ADDENDUM 3

6/4/2025
Capstone at Convington Place
24-064

The Banyan Foundation

1 FOUNDATION PLAN - 2
3/32" = 1'-0"

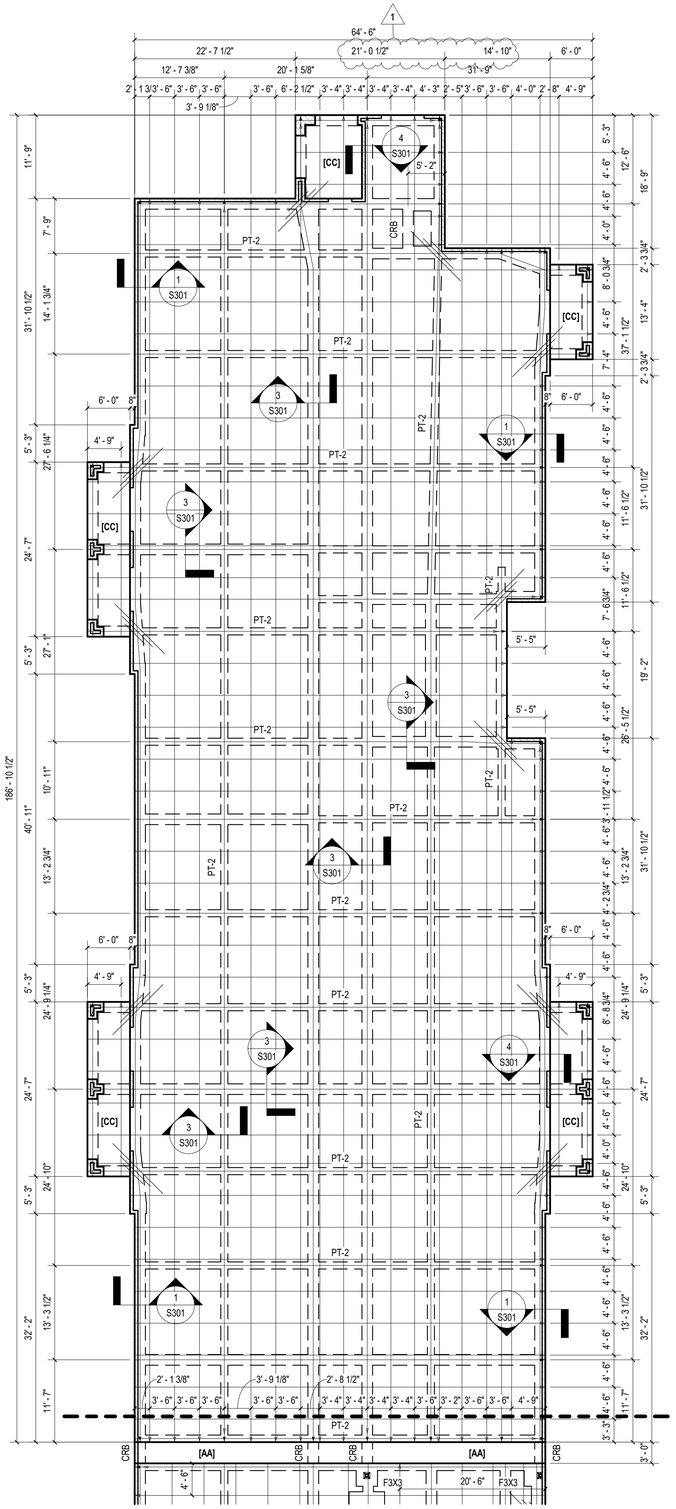
Add 1.25 **S101 – Partial Foundation Plan – 2**
- Note changes to 1S101.

1 PARTIAL SHEARWALL PLAN - 1
3/32" = 1'-0"

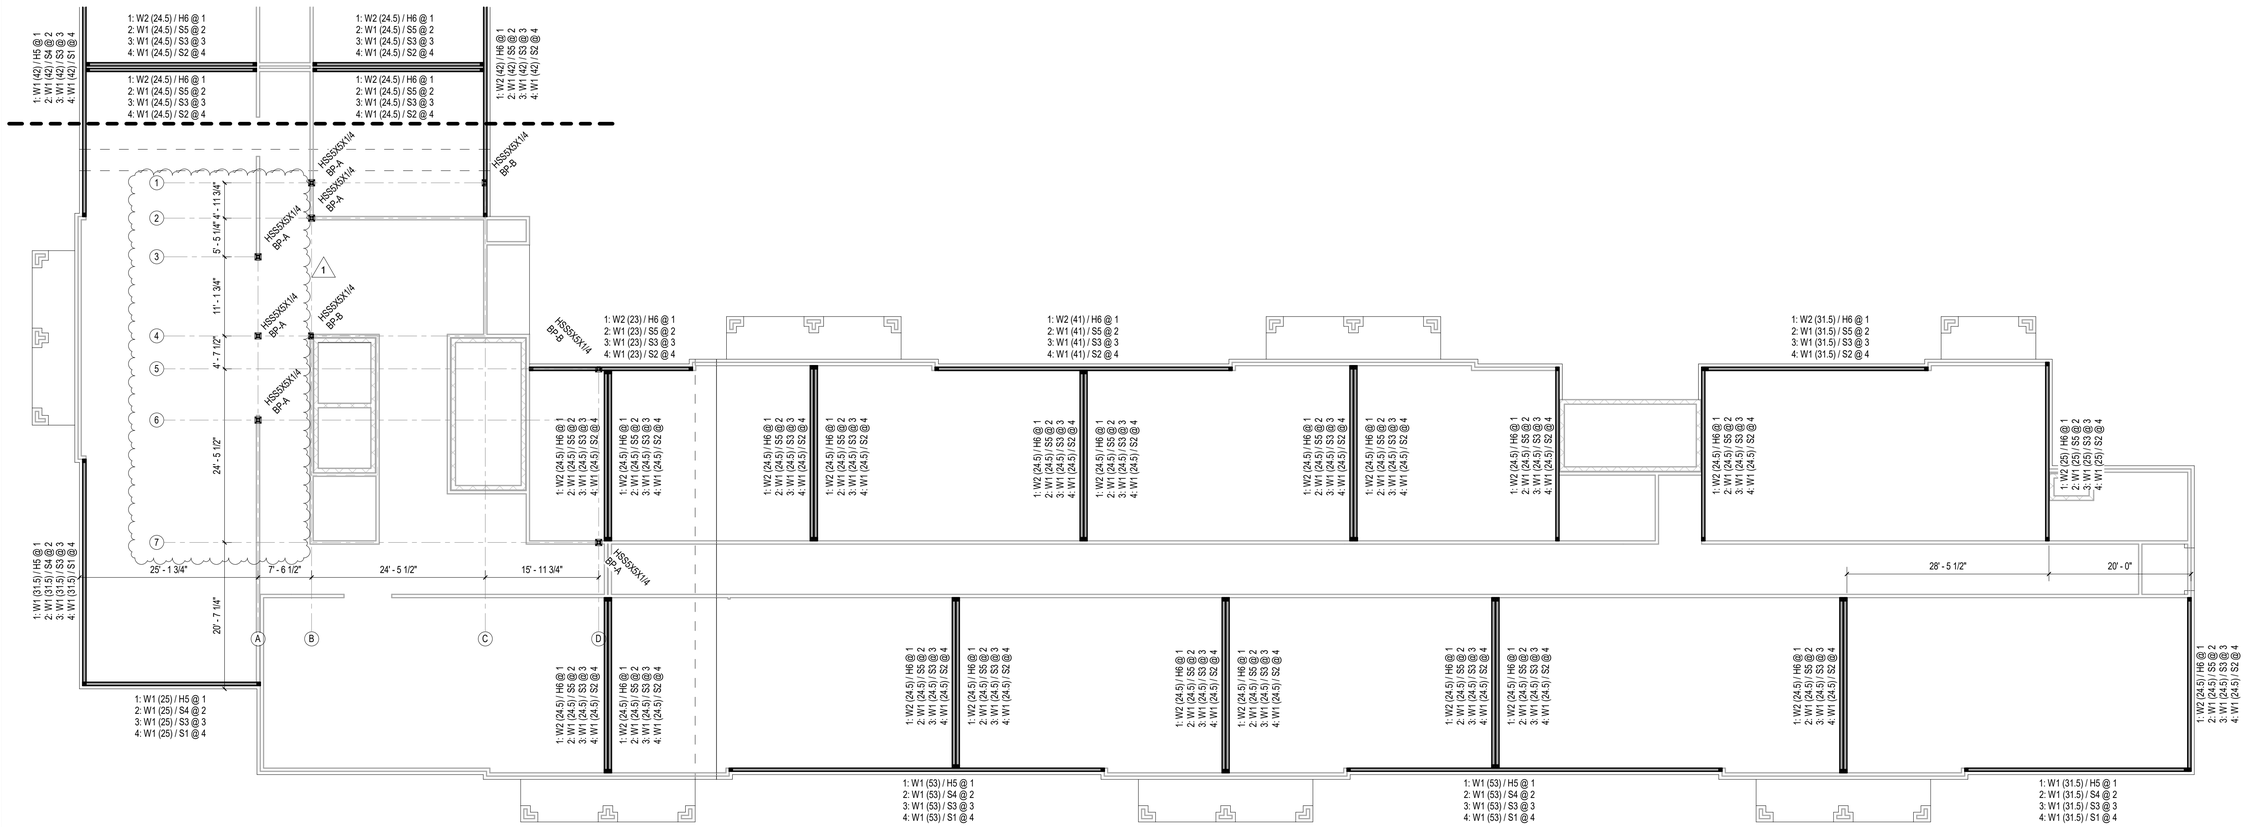
Add 1.26 **S110 – Partial Shearwall Plan – 1**
- Note changes to 1S110.

1 PARTIAL FIRST LEVEL FRAMING - 1
3/32" = 1'-0"

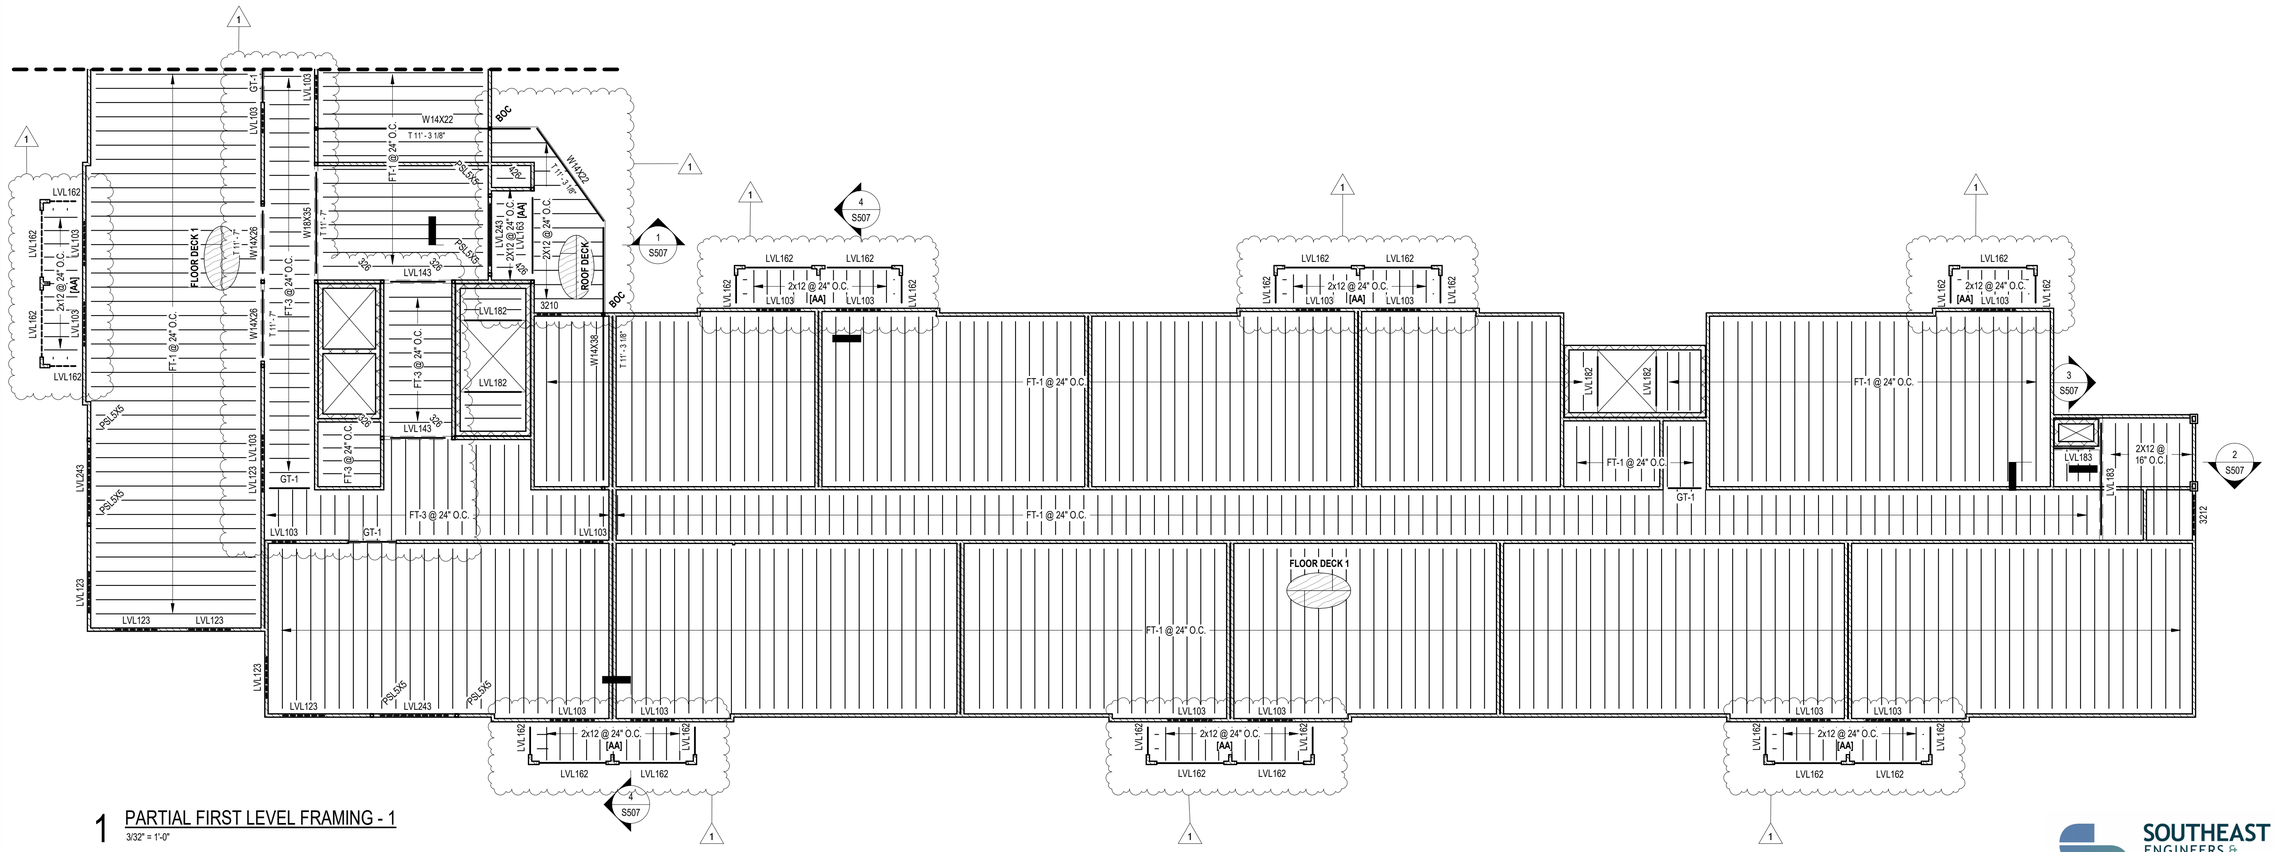
Add 1.28 **S200 – Partial First Level Framing – 1**
- Note changes to 1S200.

1 PARTIAL FIRST LEVEL FRAMING - 2
3/32" = 1'-0"

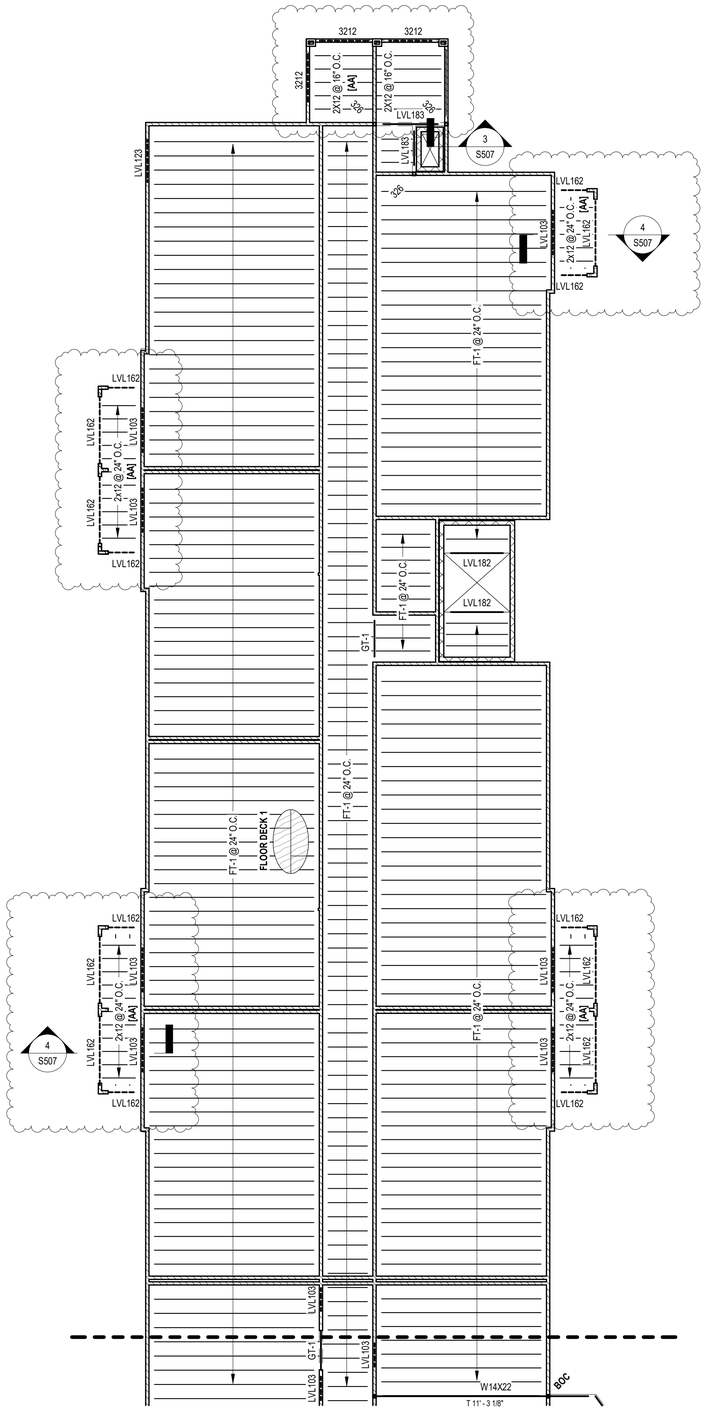
Add 1.29 **S201 – Partial First Level Framing – 2**
- Note changes to 1S201.

1 PARTIAL THIRD LEVEL FRAMING - 2

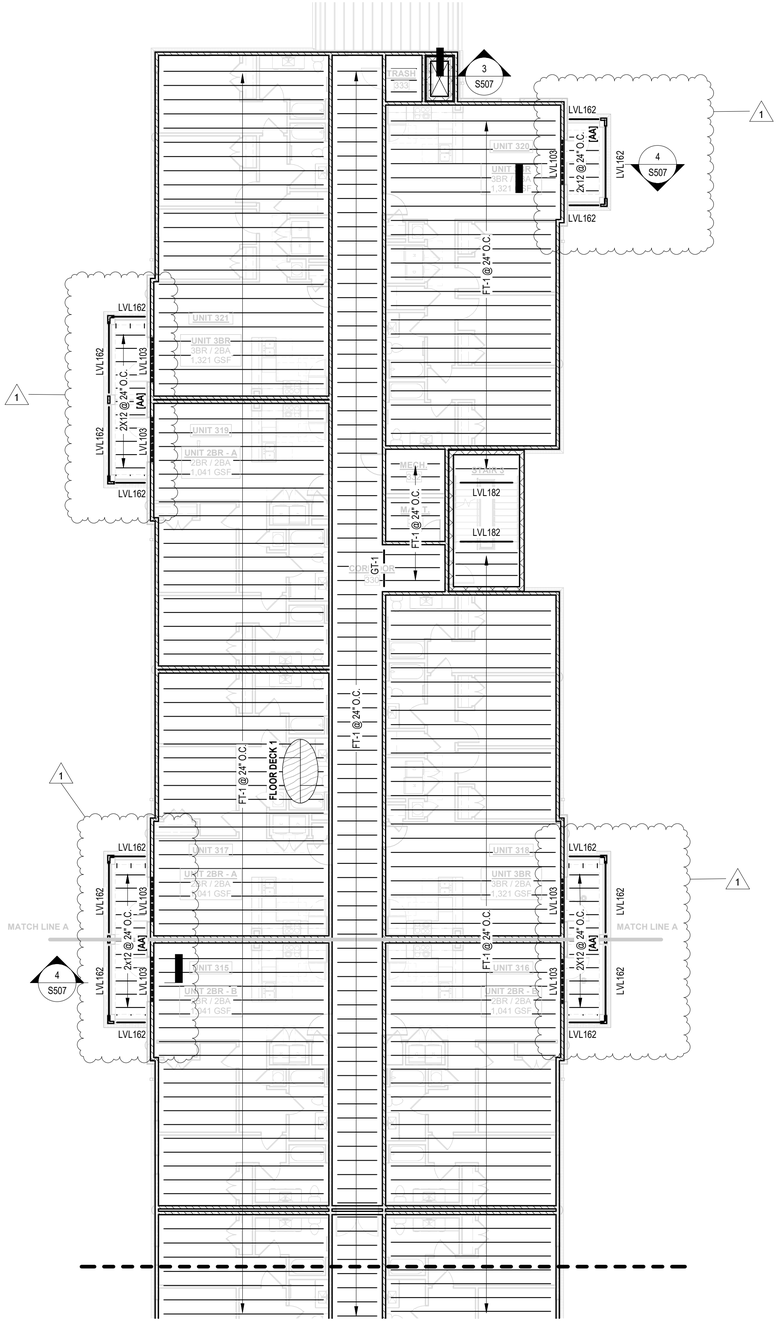
Add 1.33 **S221 – Partial Third Level Framing – 2**
- Note changes to 1S221.

1 PARTIAL ROOF FRAMING - 1
3/32" = 1'-0"

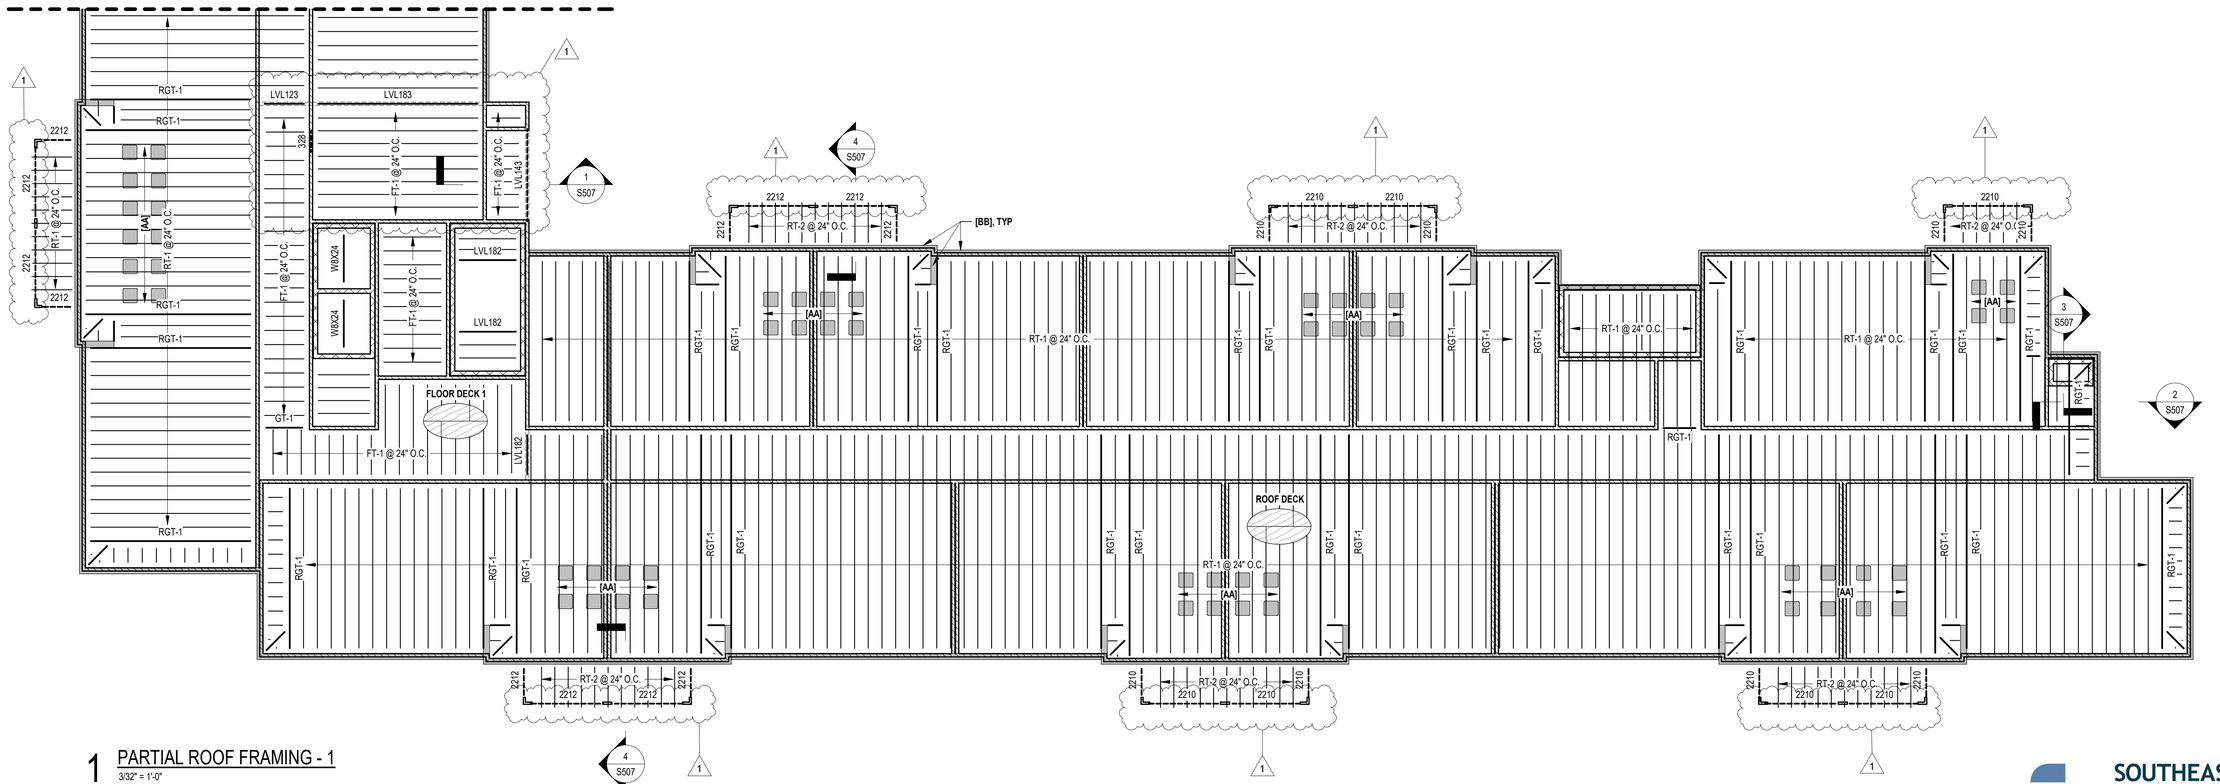
Add 1.34 **S230 – Partial Roof Framing – 1**
- Note changes to 1S230.

1 PARTIAL ROOF FRAMING - 2

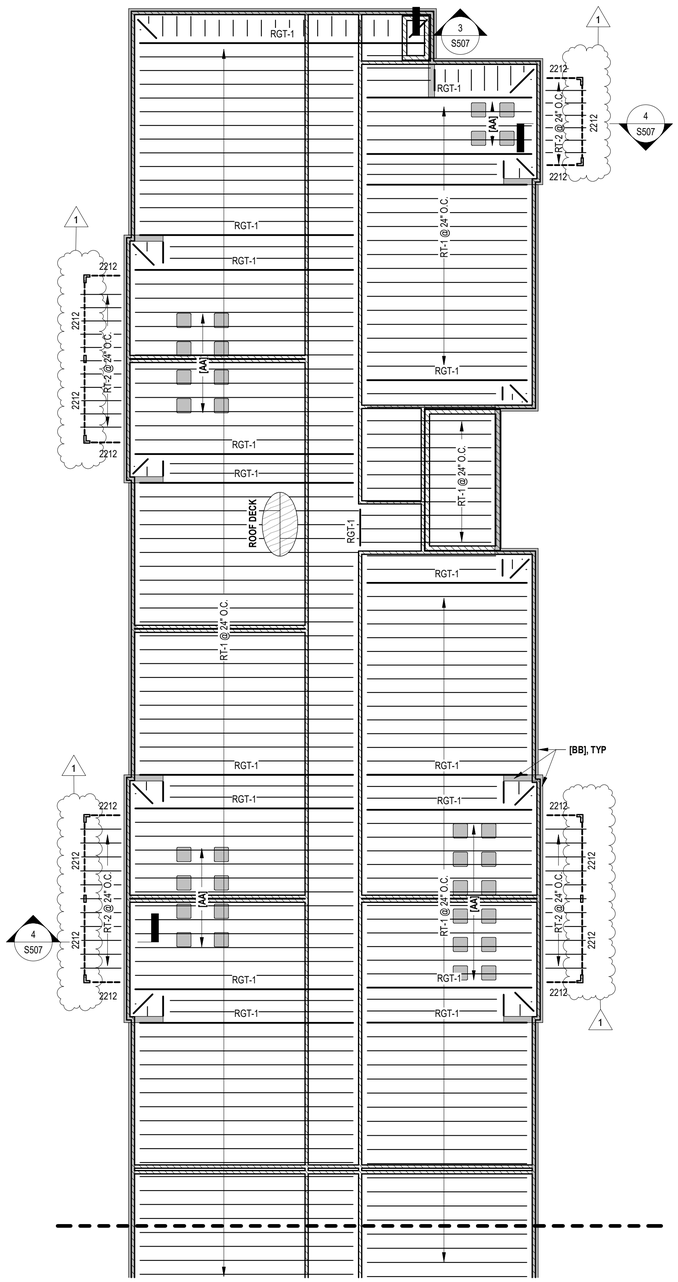
Add 1.35 **S231 – Partial Roof Framing – 2**
- Note changes to 1S231.

1 SECTION
1/4" = 1'-0"

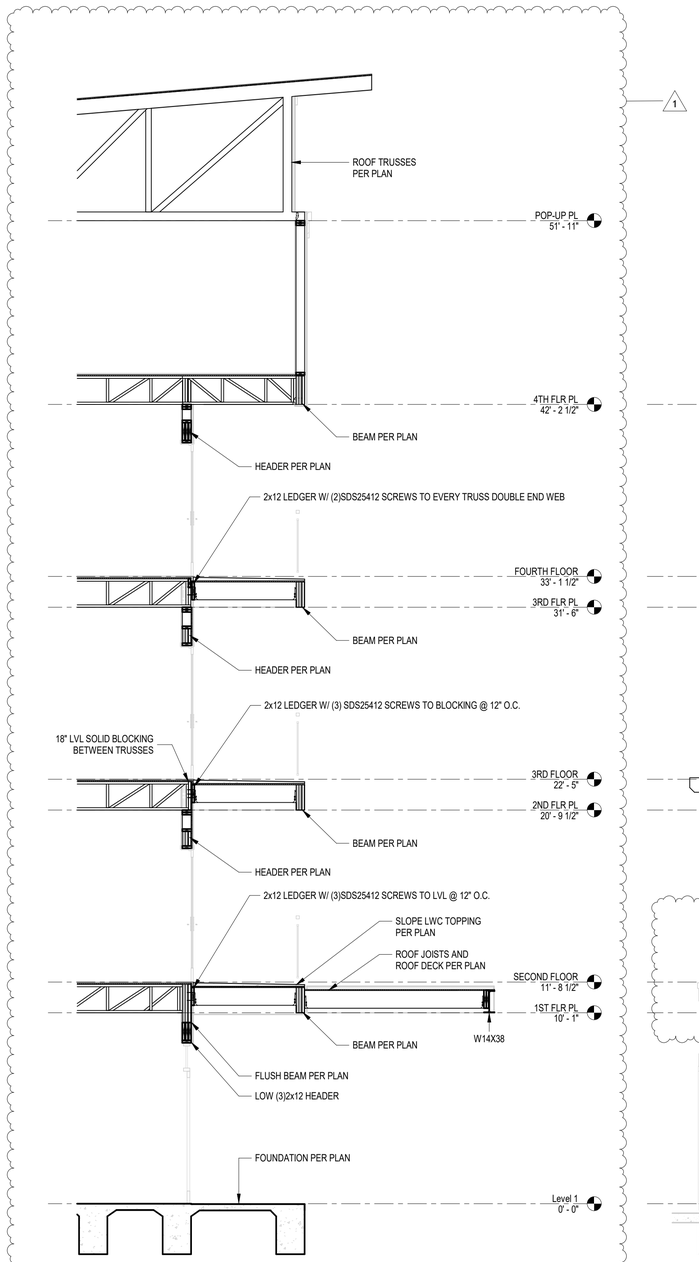
Add 1.40 **S401 – Schedules and Legends**
Add 1.41 **S500 – Details**
Add 1.42 **S501 – Details**
Add 1.43 **S502 – Details**
Add 1.44 **S503 – Details**
Add 1.45 **S504 – Details**
Add 1.46 **S505 – Details**
Add 1.47 **S506 – Details**
Add 1.48 **S507 – Details**
- Note changes to Section 1S507.
- Note changes to Section 4S507.
